Our ref.:FCA 2020-007

FIELD SAFETY CORRECTIVE ACTION

Installation of a software update on active ZEISS IOLMaster 700 with software 1.90.2.09 and 1.90.8.06

Figure 1: Mismatch between patient list and right side of patient manager.

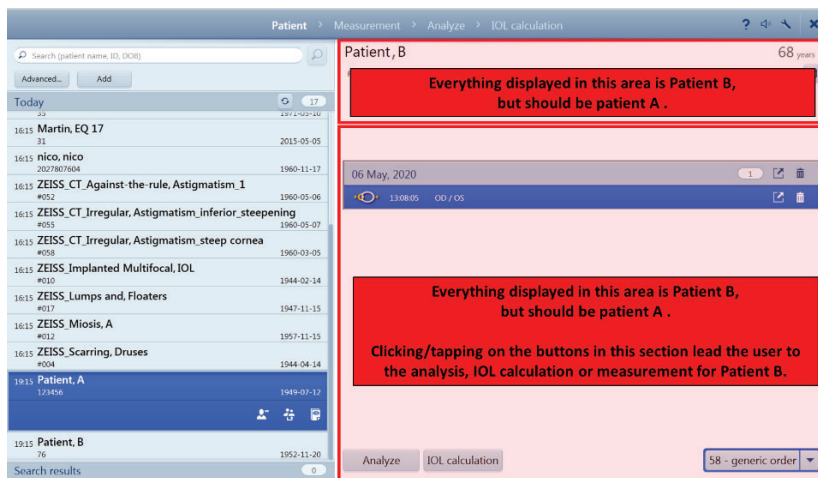
1. The user has selected patient « A » in the patient list, but patient « B » is displayed on the right side (Figure 1).
2. The user has selected patient « A » in the patient list, patient « A » is correctly displayed in the top right, but patient « B » is displayed in the bottom right (Figure 2).

This sporadic behavior leads to a false display of patients in the patient manager screen, which can subsequently lead to the implantation of a wrong intraocular lens (IOL). Therefore, a software update needs to be installed or the MWL functionality needs to be deactivated until the software update can be installed.
